Heaton Park Horticultural Centre Wall
Conservation Accredited Architect's Report on Proposals for
Rebuilding with Recommendations
October 2022

HEATON PARK HORTICULTURAL CENTRE WALL

CONSERVATION ACCREDITED ARCHITECT'S REPORT ON REBUILDING PROPOSALS WITH RECOMMENDATIONS

OCTOBER 2022

Extract from drawing no. 001, further detail would give more clarity to the submission.

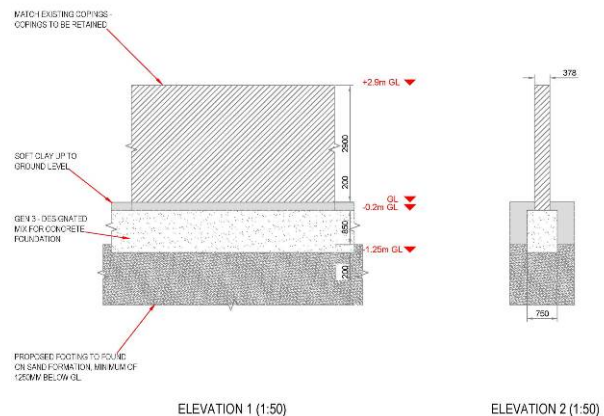
You might expect to find this information on drawing no. 001, 'New Wall and Foundations – Wall Elevations', but this comprises a 'typical' elevation and section of a short section of the wall only, lacking an overall layout indicating the position and spacing of the expansion joints or the areas of foundation renewal (unless this is intended for the complete length of the rebuilt sections of the walls).

The drawing also lacks information likely to be required by the Local Authority Conservation Officer, such as coping profile, brick coursing and bonding, and the existing nature of the footings (brick spreaders?).

- Elevations of the walls to be rebuilt as proposed, with the rebuilt sections and expansion joint positions highlighted, together with the extent of any foundation renewal
- Add detail to drawing no. 001 to show brick coursing and bonding in elevation and section, coping profile, and add notes detailing brick sizes (for any replacements required), and mortar specification for bedding and pointing (to avoid any confusion regarding the use of cement)
